Application for Variation of an Environmental Permit

**Environmental Review Report for
Alternative Arrangement for Installation of Noise Barriers and Semi-enclosures on the Island Eastern Corridor**

Central-Wan Chai Bypass –Tunnel (North Point Section) and Island Eastern Corridor Link

Figure a - Elevation for 3.5m High Noise Barrier Between Piers 17 and 22 as Temporary Noise Mitigation

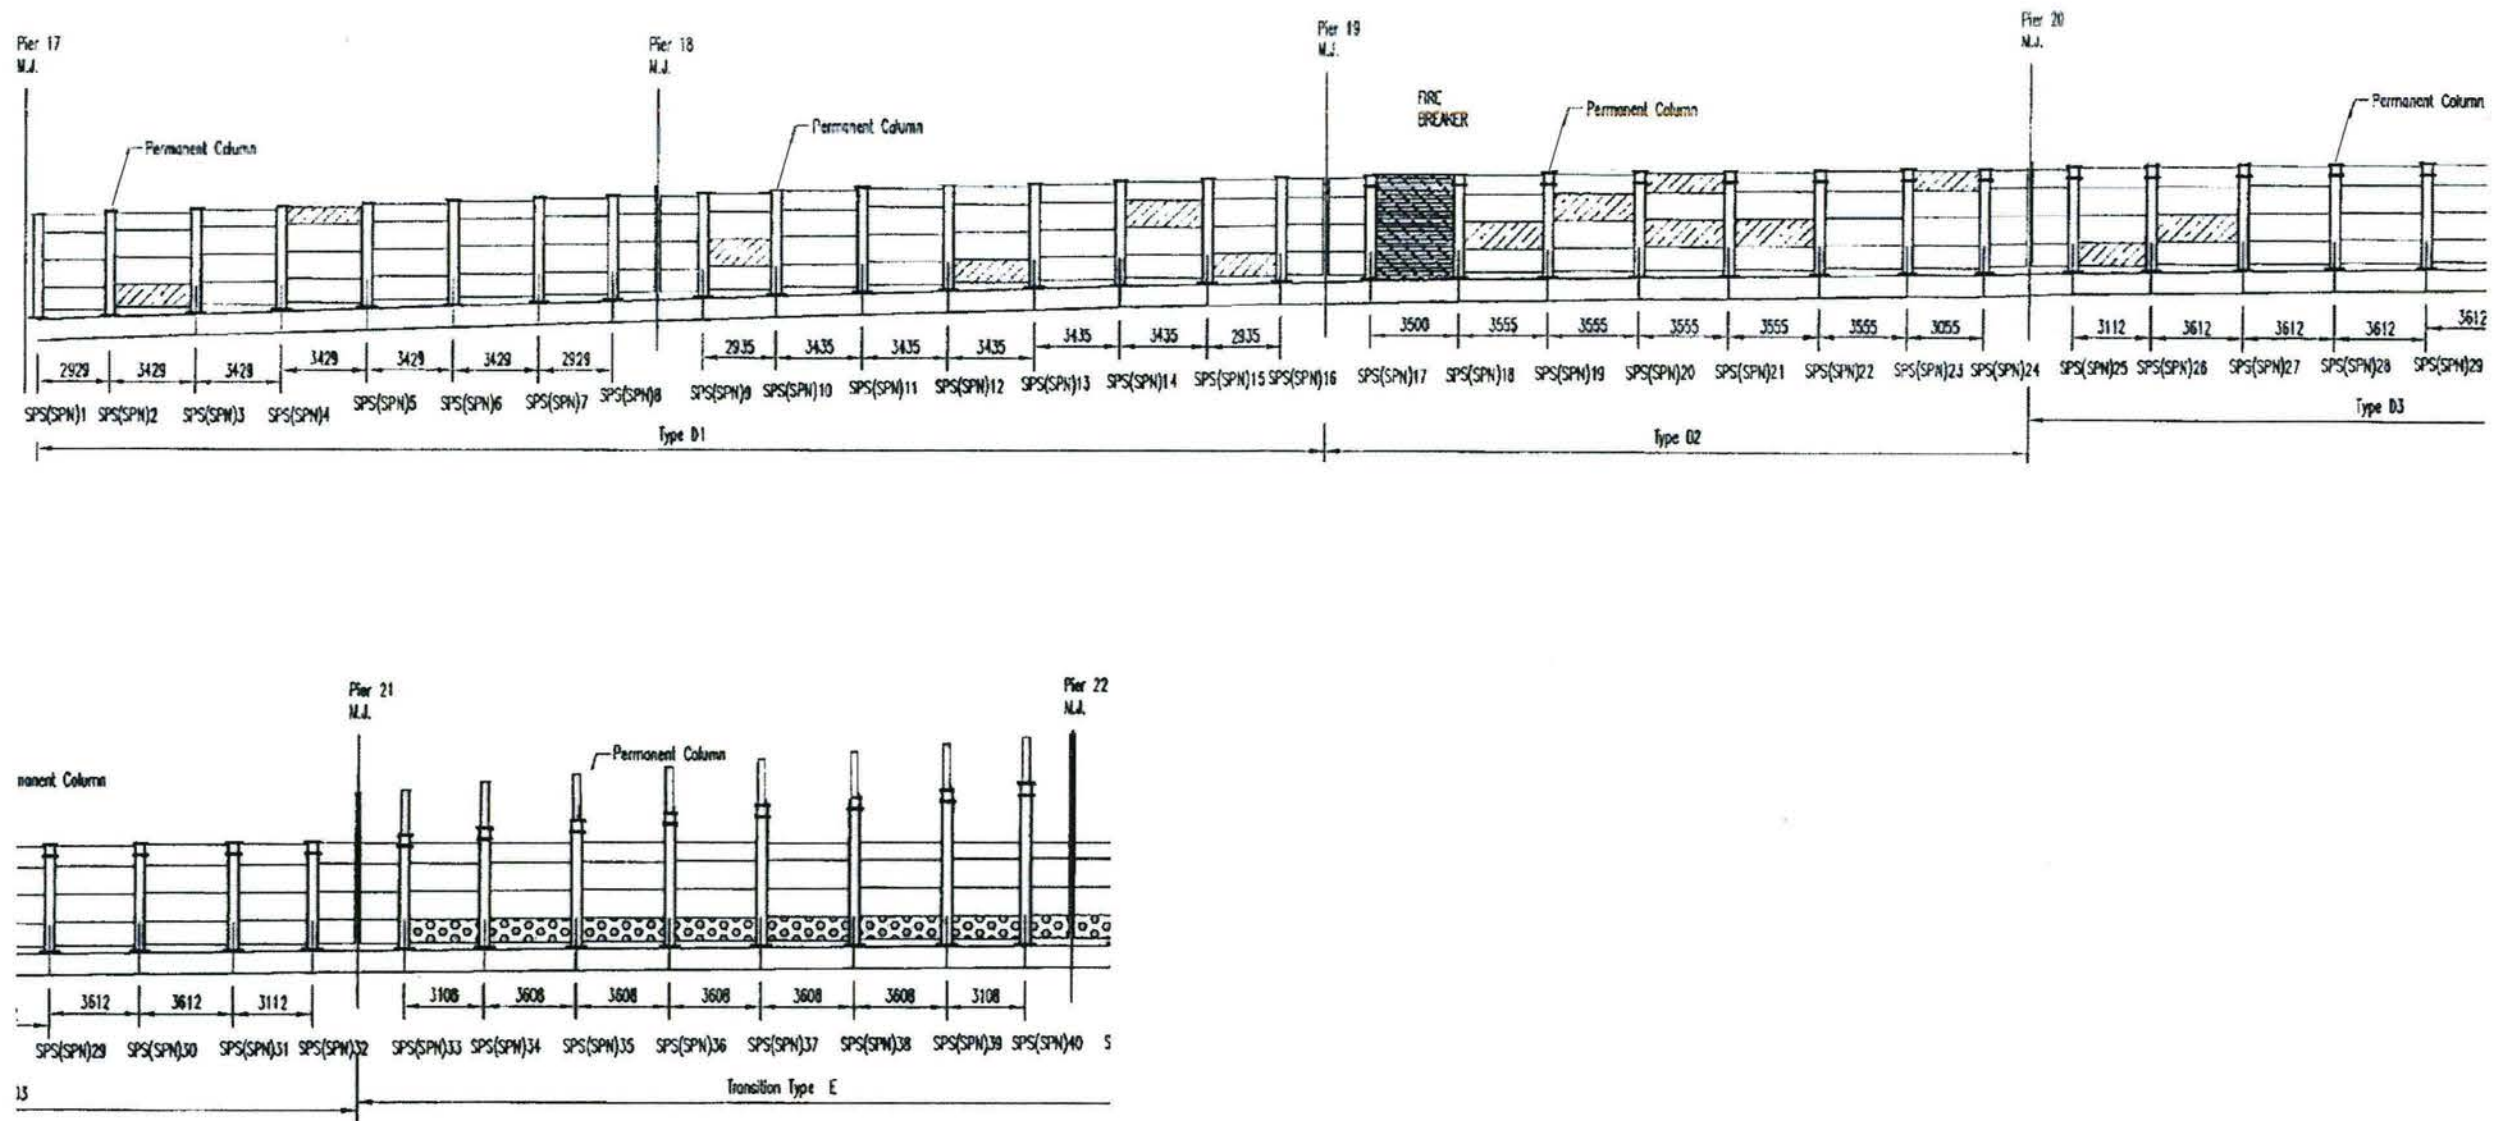
- 3.3 To mitigate the construction noise impact for the installation of the remaining permanent noise semi-enclosures due to the incomplete noise semi-enclosure between IEC westbound Pier 17 and Pier 22, a 3.5m high vertical noise barrier with PMMA panels with same specification as the noise barriers in item (a) of Condition 2.10 of the EP and FEP will be installed along the edge of IEC Pier 17 to Pier 22 as temporary noise mitigation measures (refer to **Figures a** and **b** in **Appendix 1**) prior to the commencement work of above construction work.

- 4. Conclusion**
- 4.1 With the temporary 3.5m high vertical noise barrier with PMMA panels placed as indicated in **Figures a** and **b** in **Appendix 1**, the construction noise arises from the installation of noise semi-enclosure between IEC westbound Pier 17 and Pier 22 complies with the construction noise criteria (75dB(A)).

Figure 4a: Locations of Direct Noise Mitigation Measures
 圖 4a: 直接噪音緩解措施位置圖

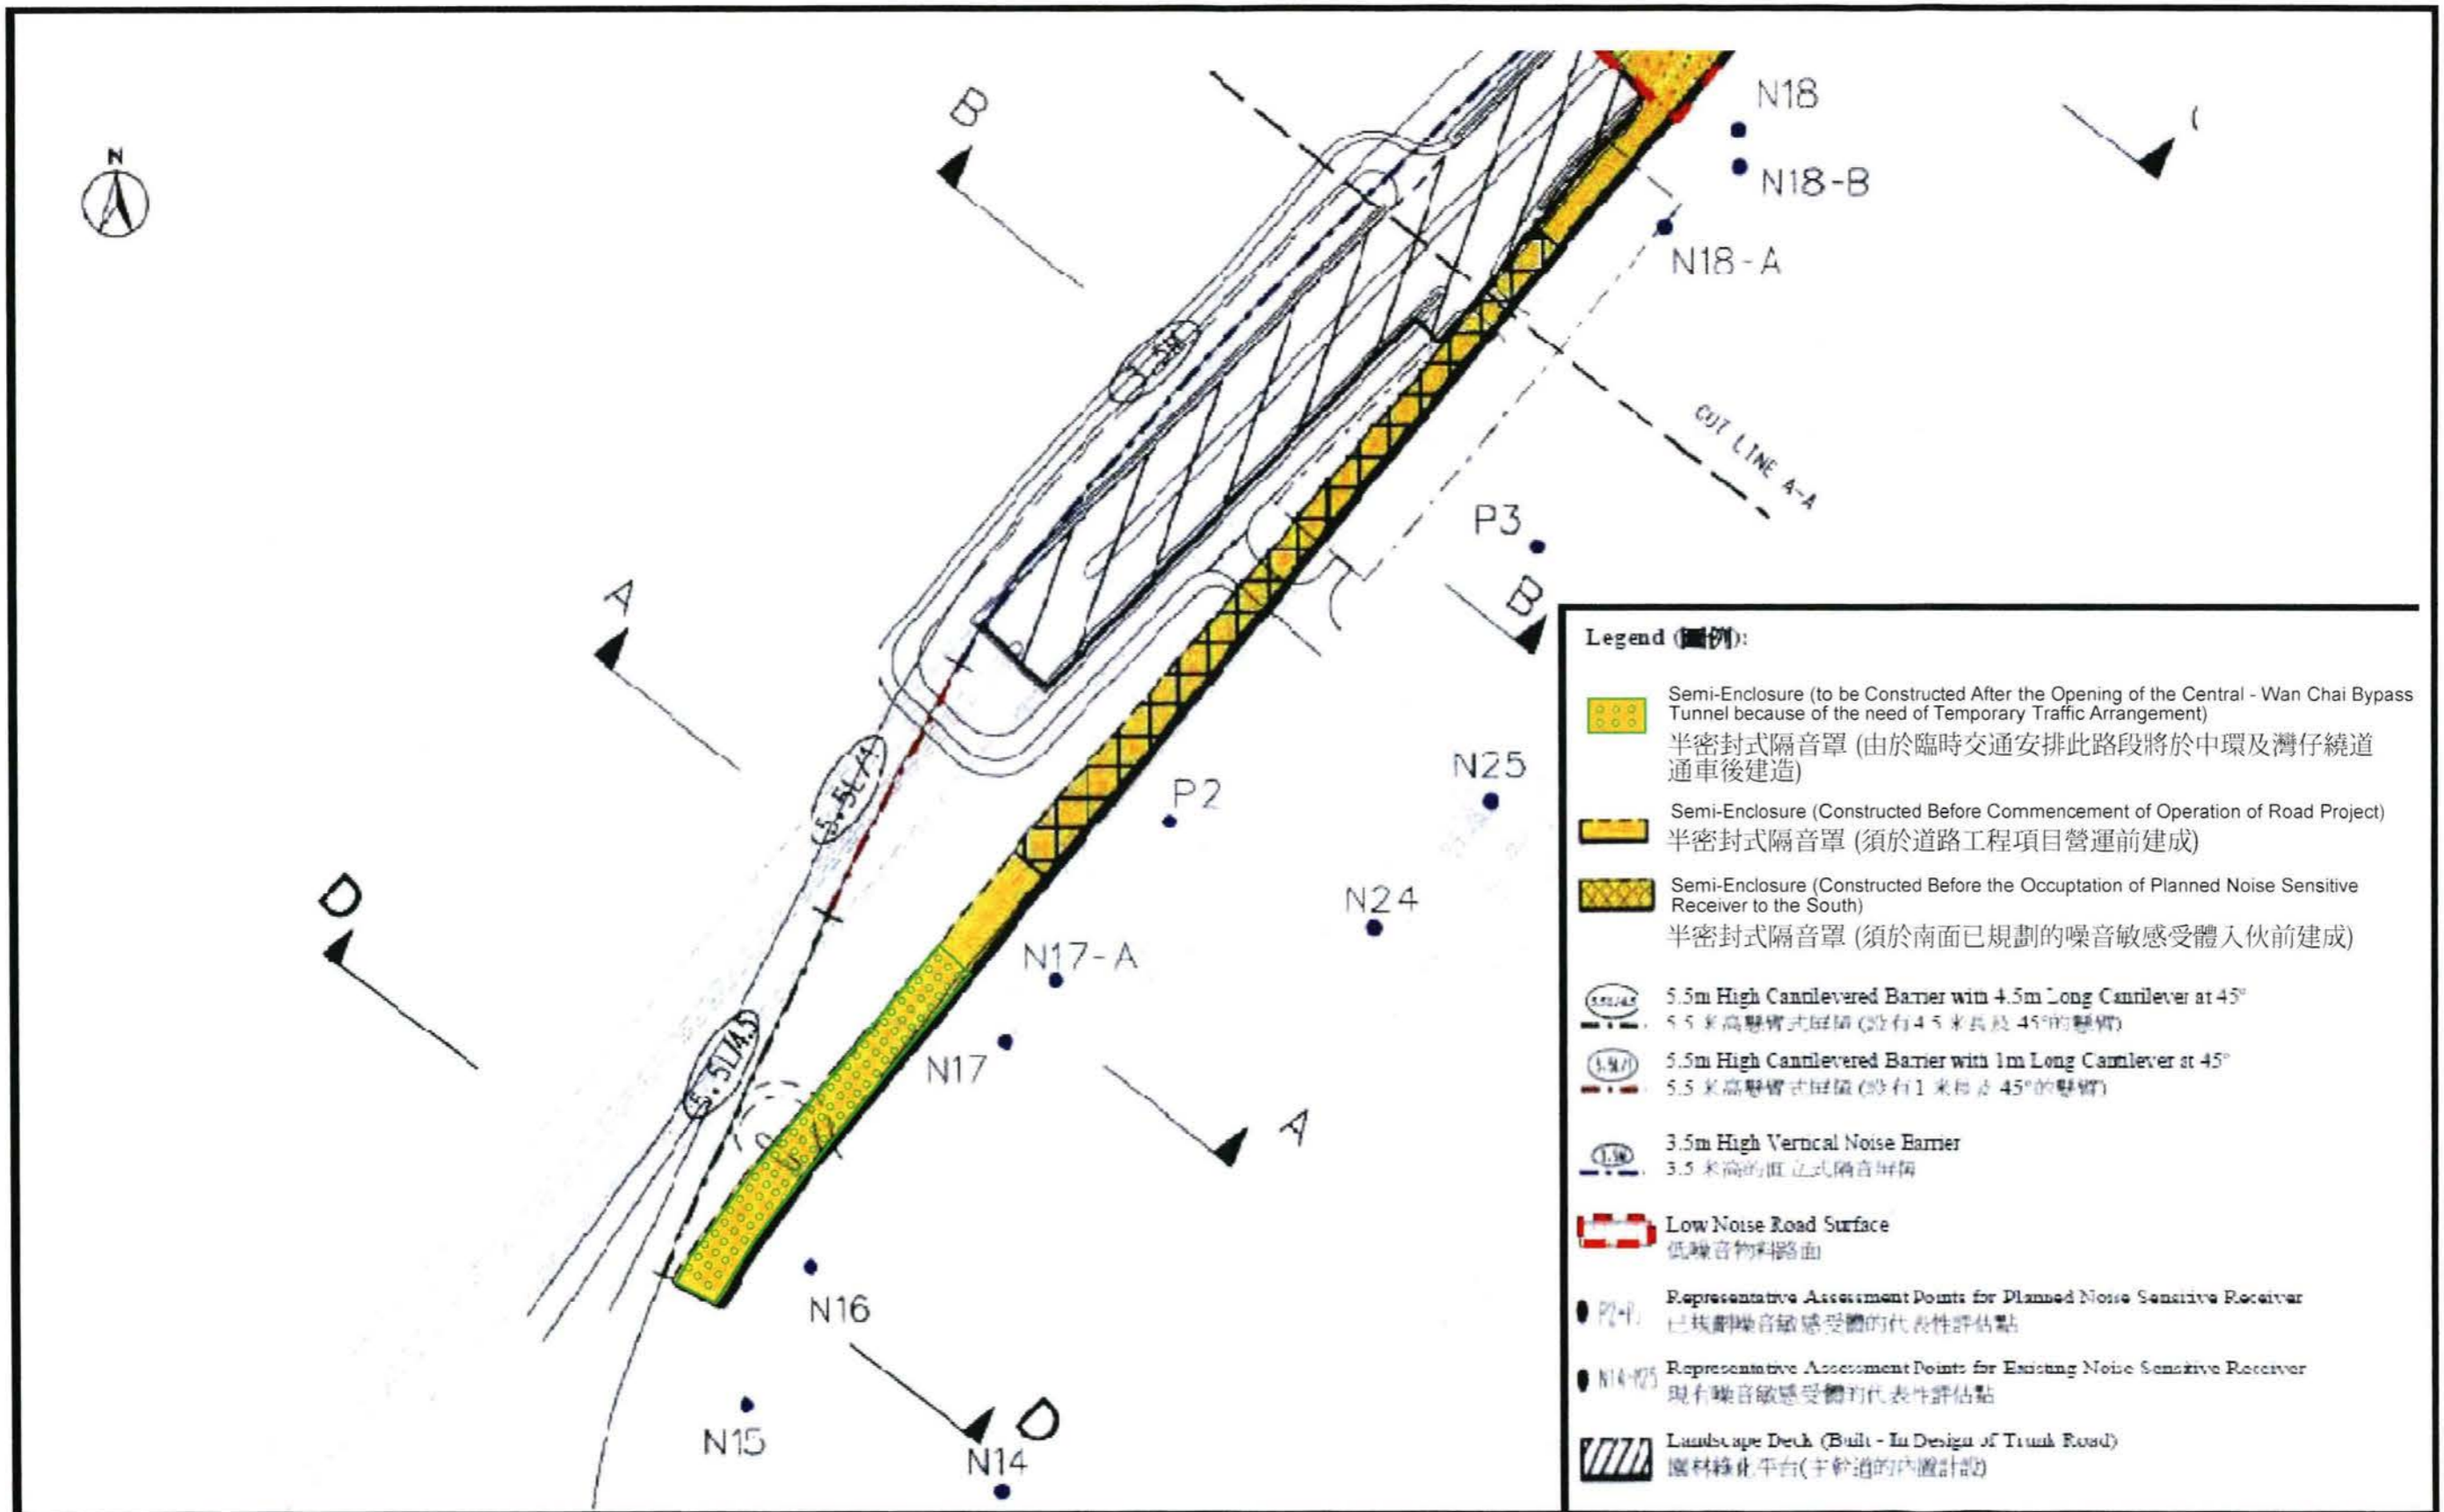
- 2.6 Temporary Traffic Arrangement (TTA) at the concerned road sections between Piers 17 and 22 will be implemented after the CWB tunnel is opened due to traffic constraint (refer to **Figure 4a** in **Appendix 1**)

Tentative Works Programme for the Installation of Noise Semi- enclosure between Pier 17 and 22

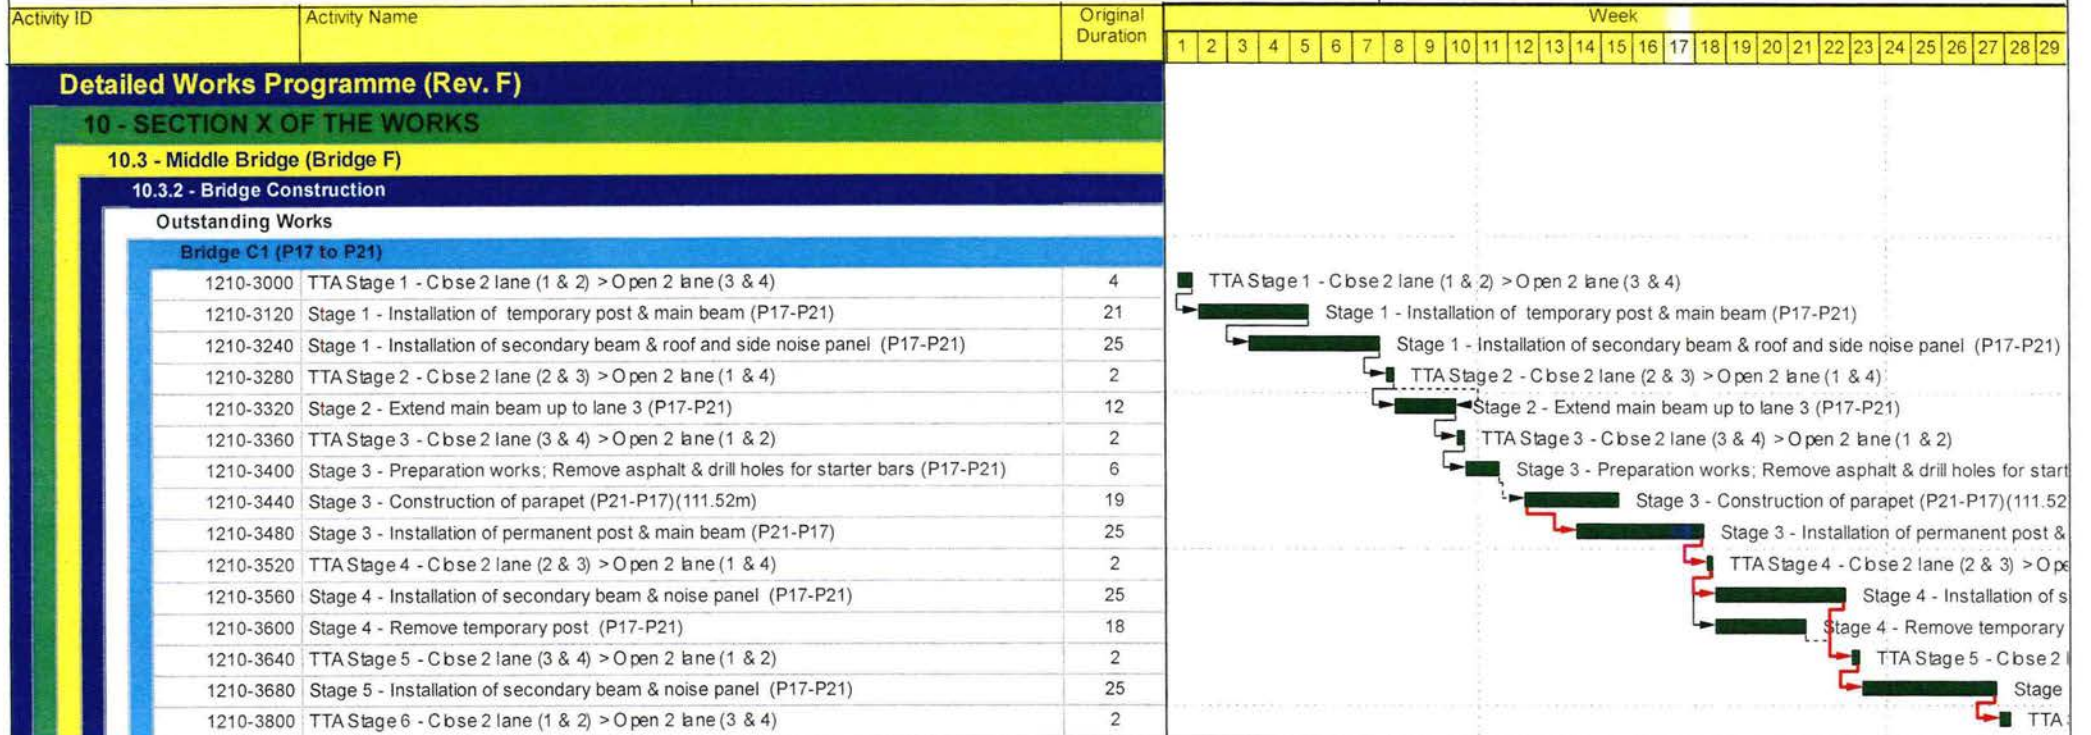
- 3.2 The remaining section of noise semi-enclosure between IEC westbound Pier 17 and Pier 22 will be completed as soon as possible after granting the approval from the TMLG members including Transport Department and Hong Kong Police Force on the traffic lane closure after CWB tunnel commissioning. Please refer to the attached works programme for the installation of noise semi-enclosure between IEC westbound Pier 17 and Pier 22 (**Appendix 3**).
